**California Traffic Control Devices Committee
Agenda Item Report**

Meeting Date: May 5, 2022	From: Gurinderpal (Johnny) Bhullar, PE, TE, Secretary to CTCDC
Item Number: 22-3	
Sponsored By: Lee Haber, PE, Caltrans	Presented By: Sarah Horn, Caltrans
Description: Proposed changes to add Clean Californian Funding Sign C49 (CA) as construction project funding identification sign for use on Clean California Projects.

Motion by committee to recommend inclusion of the Clean California Funding Sign C49(CA) to CA MUTCD Section 6F.109(CA) "Construction Project Funding Identification Signs".

Attachment D - C49A(CA) Sign Specification

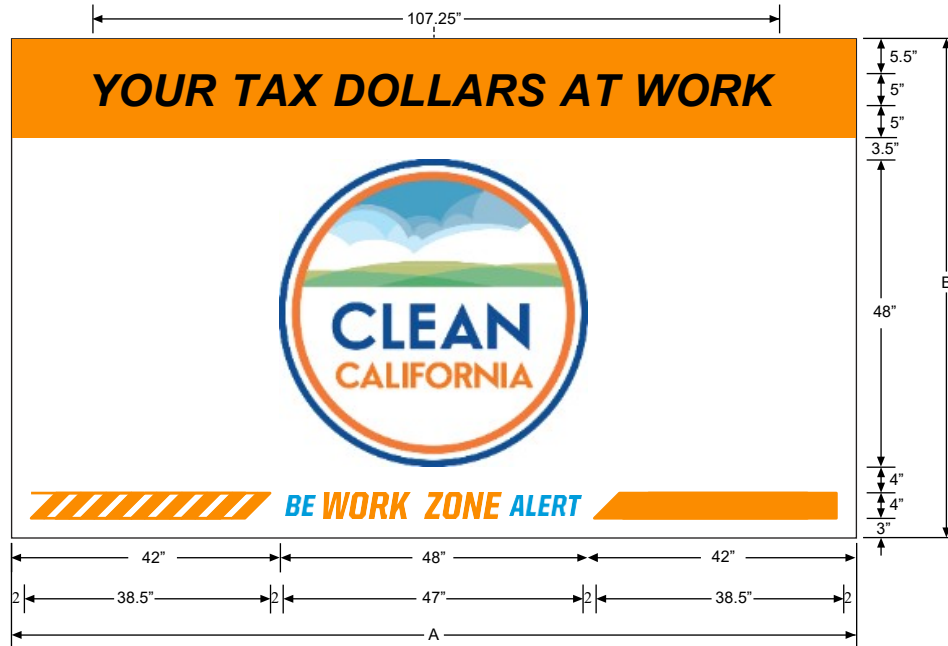
- Attachment A – Proposed changes to Section 6F.109(CA)
- Attachment B – Proposed changes to Figure 6F-101(CA) (Sheet 2 of 2)
- Attachment C – Proposed changes to Table 6F-1(CA)
- Attachment D – C49A (CA) Sign Specification
- Attachment E – C49B (CA) with SB 1 Logo Sign Specification

COLORS: LEGEND - BLACK (ARIAL BOLD ITALIC IN HEADER) BACKGROUND - WHITE AND FLUORESCENT ORANGE
CLEAN CALIFORNIA LOGO - CMYK COORDINATES FOR CLEAN CA LOGO ARE AS FOLLOWS: WILL ENTER WHEN PROVIDED
BE WORK ZONE ALERT RIBBON: PANTONE #299 BLUE AND ORANGE
SEE VECTOR GRAPHIC FILES FOR CLEAN CA LOGO AND BE WORK ZONE ALERT GRAPHICAL COLORS TO BE RETROREFLECTIVE, EXCEPT FOR BLACK

Attachment E - C49B (CA) with SB 1 Logo Sign Specification

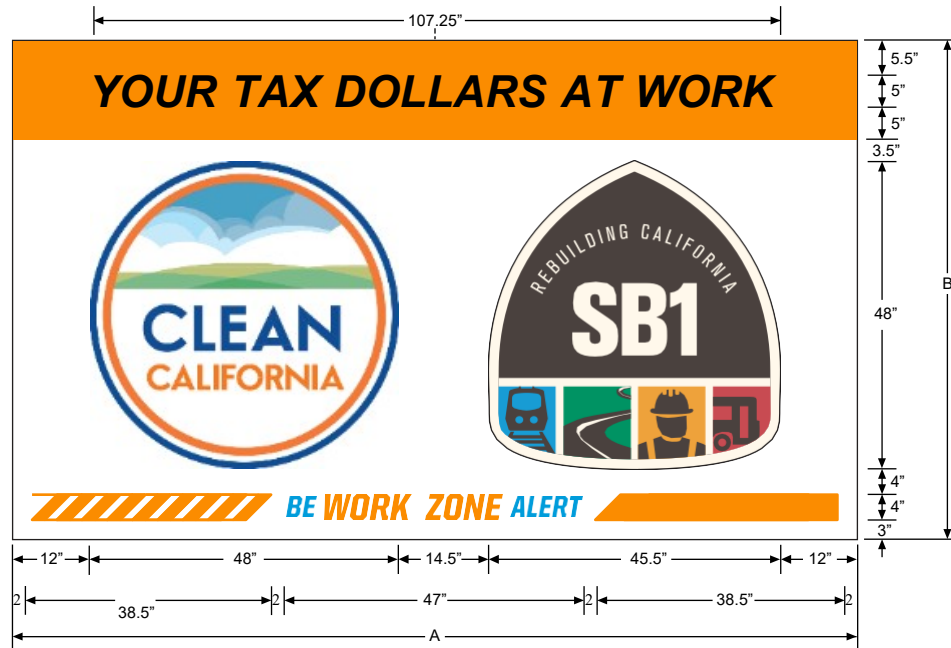
**COLORS: LEGEND - BLACK (ARIAL BOLD ITALIC IN HEADER) BACKGROUND - WHITE AND FLUORESCENT ORANGE
CLEAN CALIFORNIA LOGO - CMYK COORDINATES FOR CLEAN CA LOGO ARE AS FOLLOWS: WILL ENTER WHEN PROVIDED
BE WORK ZONE ALERT RIBBON: PANTONE #299 BLUE AND ORANGE
SEE VECTOR GRAPHIC FILES FOR CLEAN CA LOGO AND BE WORK ZONE ALERT GRAPHICAL COLORS TO BE RETROREFLECTIVE, EXCEPT FOR BLAC**
